Flight Procedures Cover Page	Task Action: FLIGHT CHECK	Task Type: SID	Estimated Chart Date: 09/05/2024	APWS Task ID: A187829E28B84E789CDE5A4857D6F851	APWS Project ID: 42465F16754147CABED308AC9737CEE6
Procedure: SID METRO FOUR DEPARTURE DETROIT MI KDTW		Enroute: YES	Specialist: Hirst, Charles		Agreement Number:
Airport ID: KDTW			Airport City: DETROIT		State: MI
Facility ID: DXO	Facility Type: VOR_DME	Flight Inspection Remark Type: New FC Slot			
<div>Procedure Comments:</div> <div>Airfield construction projects are modifying two runways at YIP. Remove RWY 7 and 25 at DET from procedure.</div> <div>8260-1 (1): WAIVER FOR ATC CLIMB GRADIENTS</div> <div>APPROVAL (2): APPROVAL FOR CLIMG GRADIENTS IN EXCESS OF 500 FT/NM APPROVAL REQUEST TO PUBLISH SPECIAL INSTRUCTIONS</div> <div>FOR ADDITIONAL QUESTIONS CONTACT ERIC SUSKI, MANAGER 405-954-7331</div> <div><div><div>3. Request Type: Waiver (DTW) DETROIT, MICHIGAN, DETROIT METROPOLITAN WAYNE COUNTY METRO FOUR DEPARTURE <a href="https://swims.faa.gov/Procedure/Edit/8531">https://swims.faa.gov/Procedure/Edit/8531</a></div><div>Requested By: FAA PRB Result: Return for Rework Waiver: No hazard identified</div><div>NON-SAFETY CRITICAL ERROR: 1.

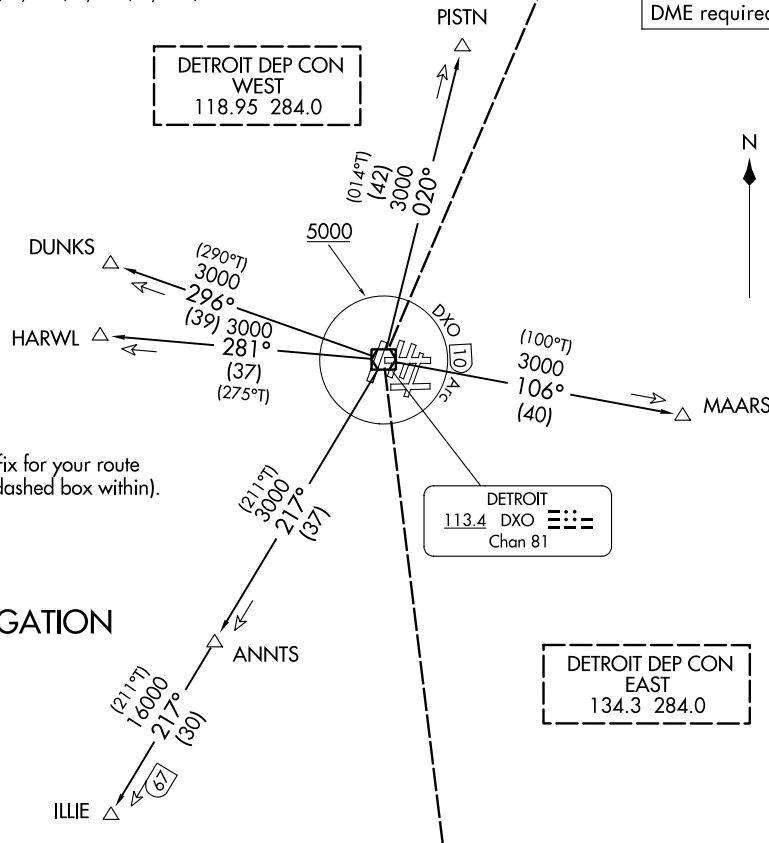
ATC is requesting approval to print special instructions on the METRO SID to segment the departure via a dashed line between the Detroit West and Detroit East Departure Control sectors.

The Detroit Metro area is a high congestion area of airspace along an international border. Having the appropriate departure frequencies already printed and presented on the METRO SID graphic will help reduce pilot confusion, improve efficiency, reduce frequency change errors, and reduce controller workload.

The Detroit Departure Control East sector 134.3 VHF/284.0 UHF will handle eastbound traffic on the MAARS transition. The Detroit Departure Control West sector 118.95 VHF/284.0 UHF will handle all of the remaining transitions: PISTN for northbound departures, DUNKS & HARWL transitions for westbound, and the ILLIE transition for southbound departures.

For appropriate departure control frequency, see graphic.  
Use frequency depicted within the sector where first navaid/fix for your route is located (sectors indicated by dashed lines; frequencies in dashed box within).

DETROIT METRO WAYNE COUNTY  
(KDTW)  
METRO FOUR DEPARTURE  
DUNKS TRANSITION  
1:500,000

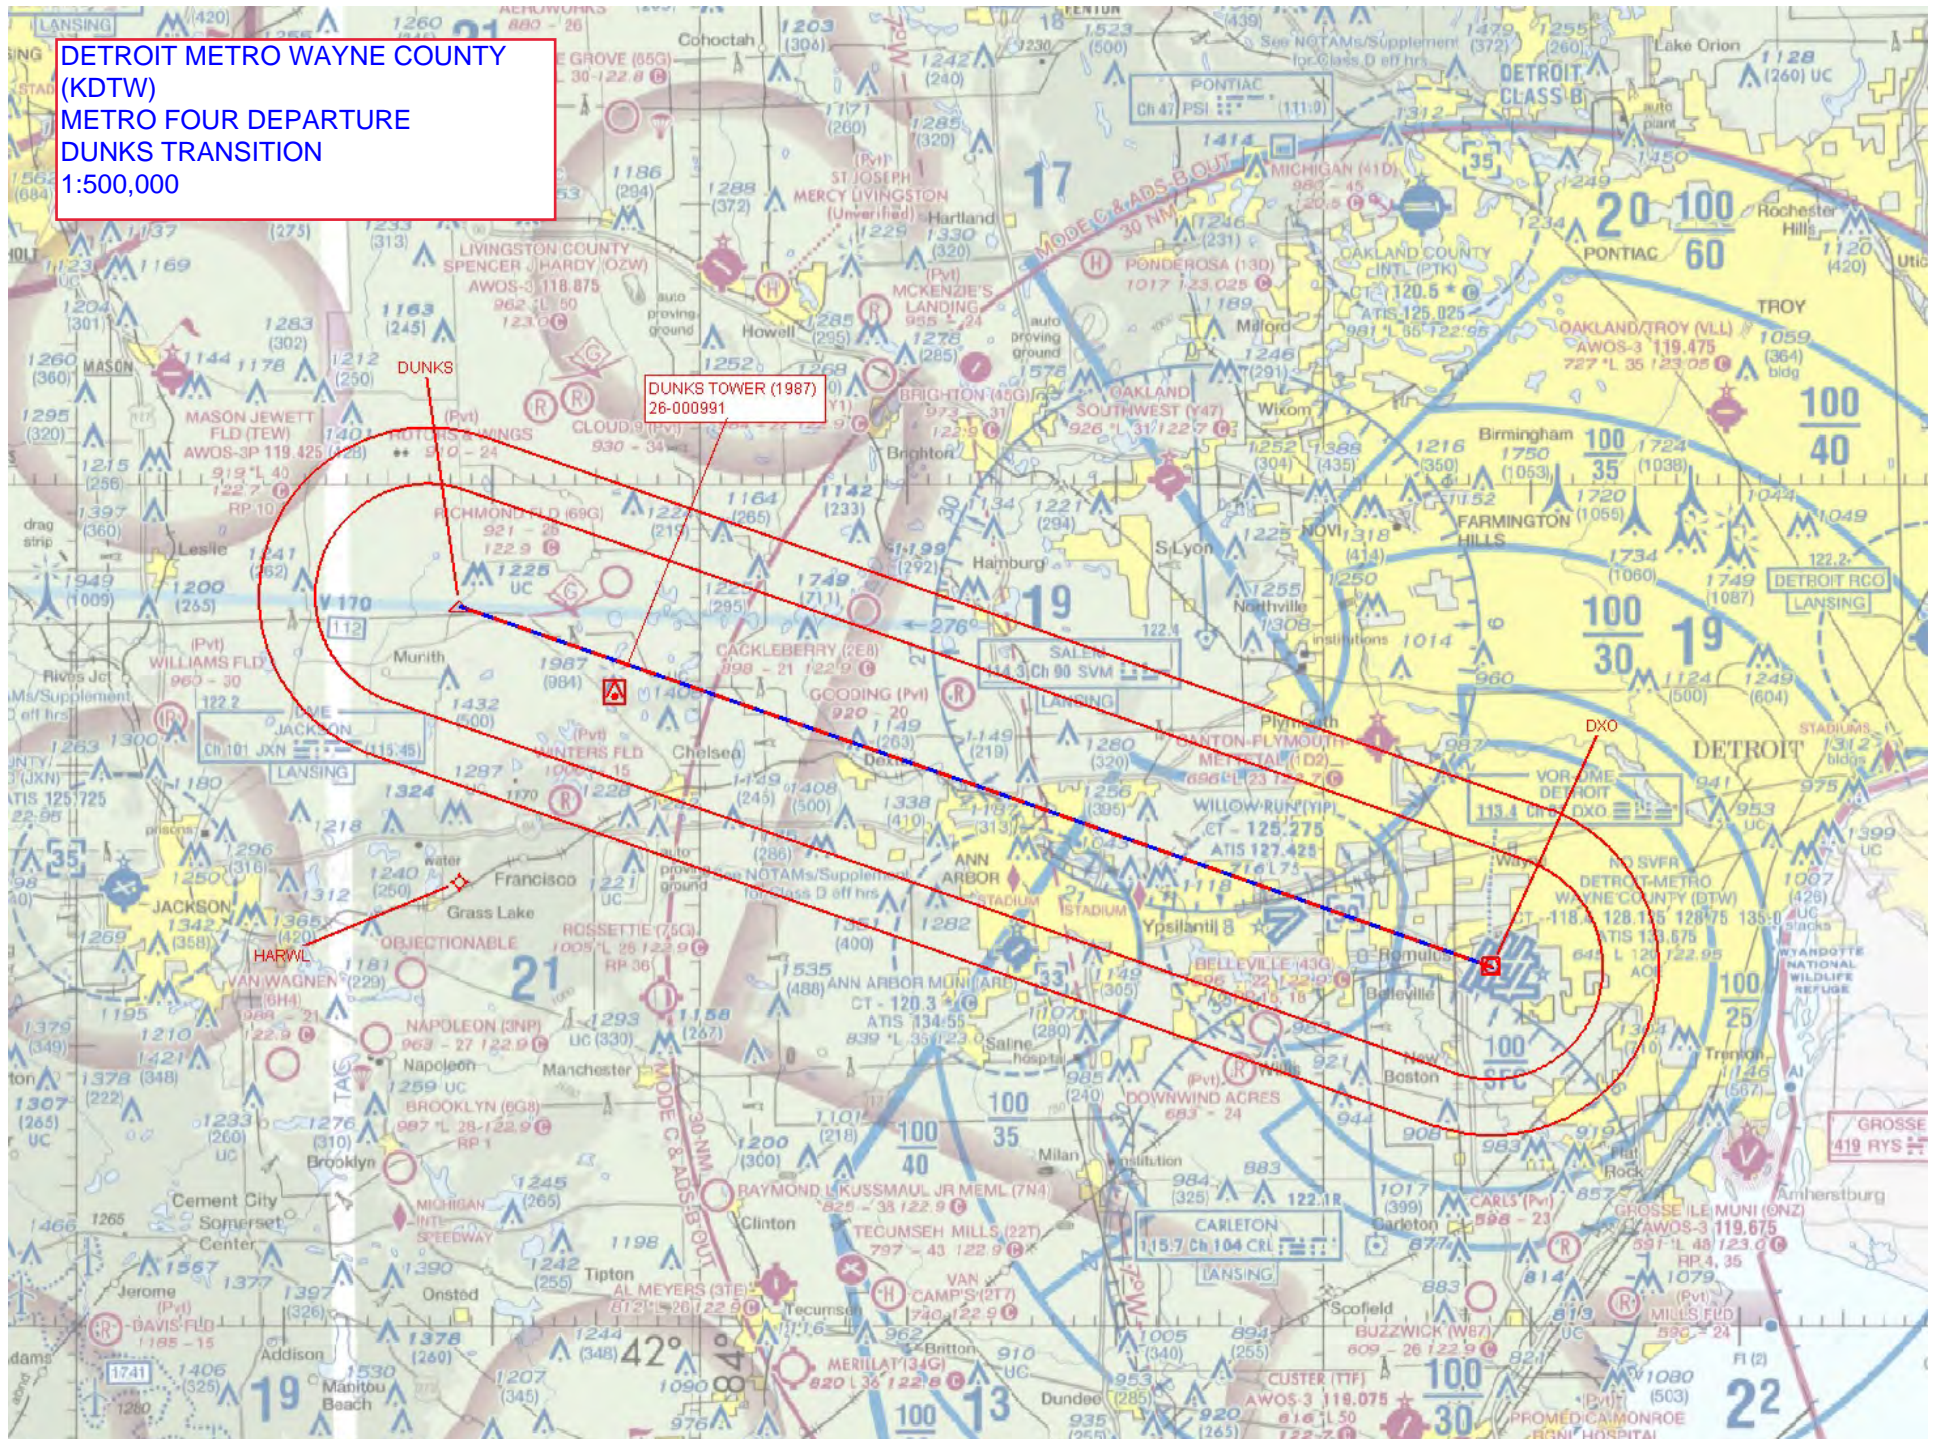
DTW ATC is requesting the crossing restriction of DXO 3.5 DME at or above 2500 MSL to ensure aircraft on the METRO SID can be vectored to the west without conflicting with Willow Run Airport (KYIP) traffic.

The KYIP VOR-A approach comes in from the NW, is CIRCLING ONLY, and has the aircraft descending to a 1420 MSL Circling MDA. If the aircraft on final circle SE of KYIP, they come within 1.85 NM of the DXO 3.5 NM DME arc. The DXO 3.5 DME crossing restriction at 2500 MSL would ensure 1000 foot separation from the KYIP VOR-A traffic with METRO SID aircraft off of KDTW.

Additionally, KYIP RNAV (GPS) RWY 23 crosses GAFFY at 1500 MSL. Crossing DXO 3.5 DME at 2500 on the METRO SID for KDTW departures will also ensure IFR separation and deconflict aircraft flying the KYIP RNAV (GPS) RWY 23 approach.

ALL AIRCRAFT: ATC climb gradient: If unable to accept climb rate, advise ATC prior to taxi.

RUNWAY 3R: Cross DXO 3.5 DME at or above 2500 MSL, 820' /NM to 2500.

RUNWAY 3L: Cross DXO 3.5 DME at or above 2500 MSL, 737' /NM to 2500.

RUNWAY 4R: Cross DXO 3.5 DME at or above 2500 MSL, 856' /NM to 2500.

RUNWAY 4L: Cross DXO 3.5 DME at or above 2500 MSL, 669' /NM to 2500.

RUNWAY 9R: Cross DXO 3.5 DME at or above 2500 MSL, 1046' /NM to 2500.

RUNWAY 9L: Cross DXO 3.5 DME at or above 2500 MSL, 988' /NM to 2500.

RUNWAY 21 R: Cross DXO 3.5 DME at or above 2500 MSL, 538' /NM to 2500.

RUNWAY 21 L: Cross DXO 3.5 DME at or above 2500 MSL, 687' /NM to 2500.

RUNWAY 22R: Cross DXO 3.5 DME at or above 2500 MSL, 742' /NM to 2500.

RUNWAY 22L: Cross DXO 3.5 DME at or above 2500 MSL, 661' /NM to 2500.

RUNWAY 27R: Cross DXO 3.5 DME at or above 2500 MSL, 511' /NM to 2500.

RUNWAY 27L: Cross DXO 3.5 DME at or above 2500 MSL, 521' /NM to 2500.
